Access Compliance Report

Public Rights-of-Way

Intersection ID: 46930	Main Street: SUTTER_CREEK_LN	Cross Street: LIVERMORE_LN	Location: SW
ADA ID: A4C4B092B066	Ramp Type: BlendTrans2	Initial Pass/Fail: Fail	Overall Compliance: No
		Severity Score: 12.5

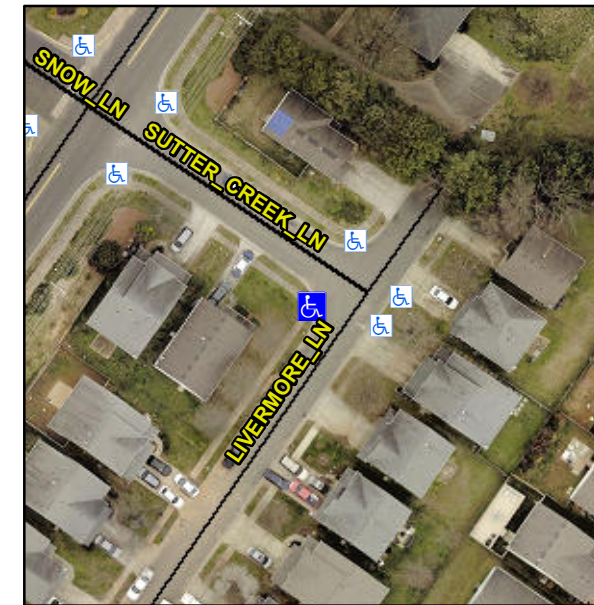
Not Found, R304.5.3

Compliance	Description	Data	Compliance	Description	Data
N/A	Ramp Length (in)	96.0	Yes	BlendTrans Slope (%)	3.7
Yes	Ramp Width (in)	48.0	No	BlendTrans XSlope (%)	5.3
N/A	Flare Type LT	N/A	N/A	Flare Type RT	N/A
N/A	Flare Slope LT (%)	N/A	N/A	Flare Slope RT (%)	N/A
N/A	Flare Traversable LT?	N/A	N/A	Flare Traversable RT?	N/A
N/A	Landing Length (in)	N/A	N/A	DWS Provided?	N/A
N/A	Landing Width (in)	N/A	N/A	DWS Contrast?	N/A
N/A	Landing Slope (%)	N/A	N/A	DWS Length (in)	N/A
N/A	Landing X Slope (%)	N/A	N/A	DWS Full Width?	N/A
N/A	Landing Curb? (Y/N)	N/A	N/A	DWS Offset (in)	N/A
N/A	Shared Landing?	N/A			
N/A	Gutter Ponding?	N/A	N/A	Gutter Slope (%)	N/A
N/A	Gutter Lip Ht (in)	N/A	N/A	Gutter X Slope (%)	N/A
N/A	Painted X Walk1?	No	N/A	Painted X Walk2?	No
	X Walk 1 Direction	To SE		X Walk 2 Direction	To NE
	X Walk 1 Width (in)	N/A		X Walk 2 Width (in)	N/A
	X Walk 1 Slope (%)	1.8		X Walk 2 Slope (%)	0.5
	X Walk 1 X Slope (%)	0.4		X Walk 2 X Slope (%)	0.9

Remove & Replace Curb Ramp With Two New Directional Ramps or Equivalent.
